APPLICATION NO.	FILING DATE	FIRST NAMED INVENTOR	ATTORNEY DOCKET NO.	CONFIRMATION NO.
10/722,552	11/28/2003	Ming Fu Teng	BHT-3123-110	8356

Office Action Summary

This is a first office action on the merits of application SN 10/722,552.

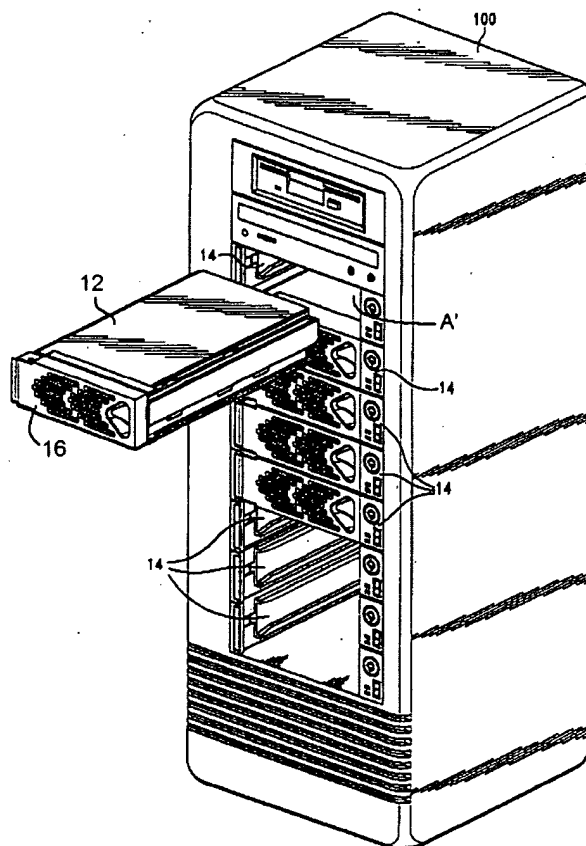
7. Claims 1, 4, and 6 are rejected under 35 U.S.C. 102(b) as being clearly anticipated by U.S. Patent 6,130,822 to Della Fiora. Della Fiora '822 discloses a bay cover (26) on a front panel (22) of a computer chassis (20), being covered on a corresponding bay slot (24) on a front panel (22). The bay cover (26) and the bay slot (24) being disposed on the same side and respectively comprise an axle (46,48) and a

corresponding axle hole (68) for movably opening and closing the bay cover (26) so that a computer peripheral can be installed or removed without removing the front panel (22) and the bay cover (26).

8. Regarding claim 4, the other side of the bay cover (26) has a latch (36) for latching the bay slot (24).

9. Regarding claim 6, the bay cover (26) is substantially convex outside and concave inside, for covering the exposed area of the computer peripheral as best seen in figure 2a and 2b.

Behl '339 Figure 10

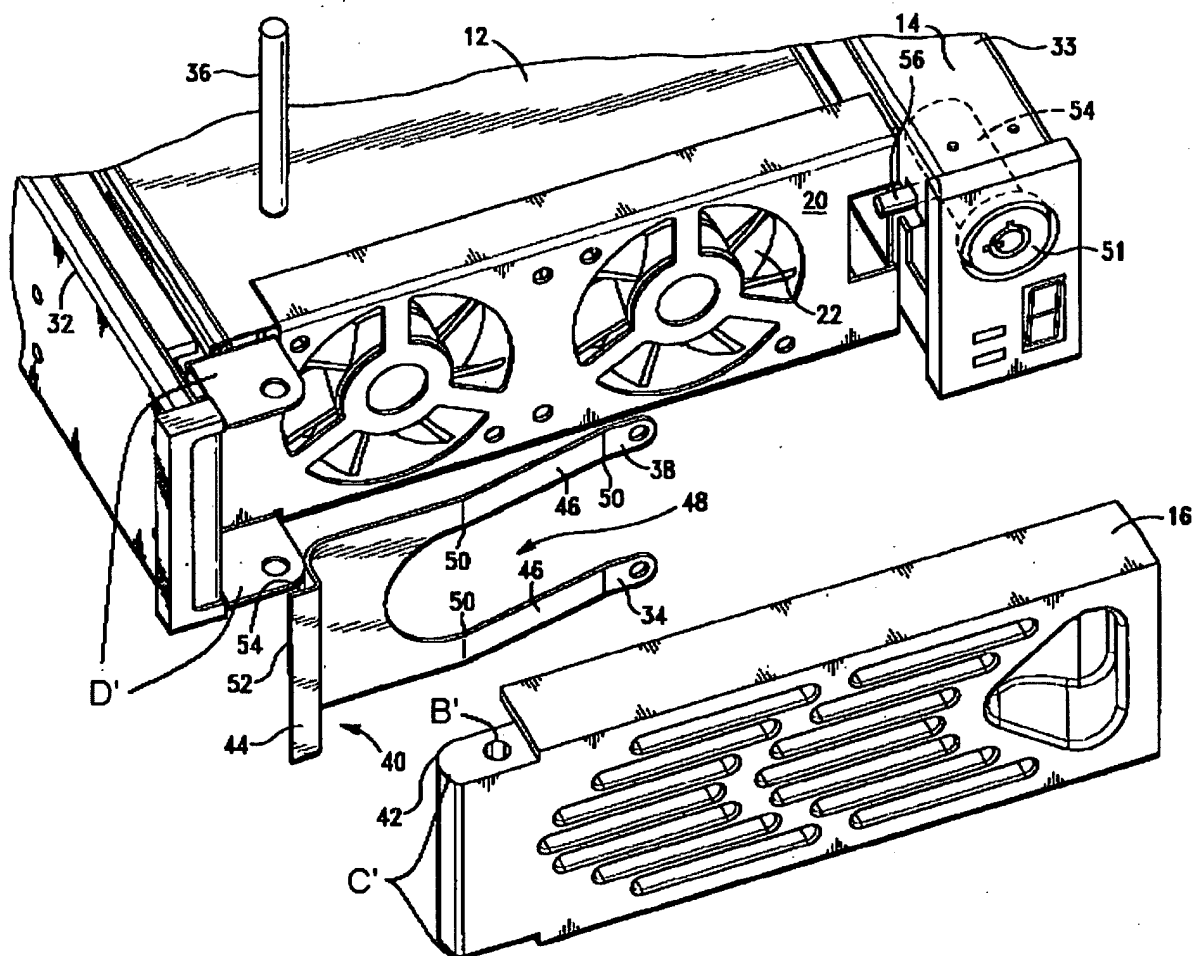
13. Claims 1-3 and 7 are rejected under 35 U.S.C. 102(b) as being clearly anticipated by U.S. Patent 6,193,339 to Behl. Behl '339 discloses a bay cover (16) on a front panel (14) of a computer chassis (100), being covered on a corresponding bay slot (A') on a front panel (14). The bay cover (16) and the bay slot (A') being disposed on the same side and respectively comprise an axle (36) and a corresponding axle hole (B') for movably opening and closing the bay cover (16) so that a computer peripheral (12) can be installed or removed without removing the front panel (14) and the bay cover (16).

14. Regarding claim 2, the bay slot (A') at one end respectively there is an upper and lower symmetrical axle arms (D') extended outward, and the axle arms at their corresponding surfaces on the free end respectively has an axle (36) when the axle is put through the holes on the arms (D').
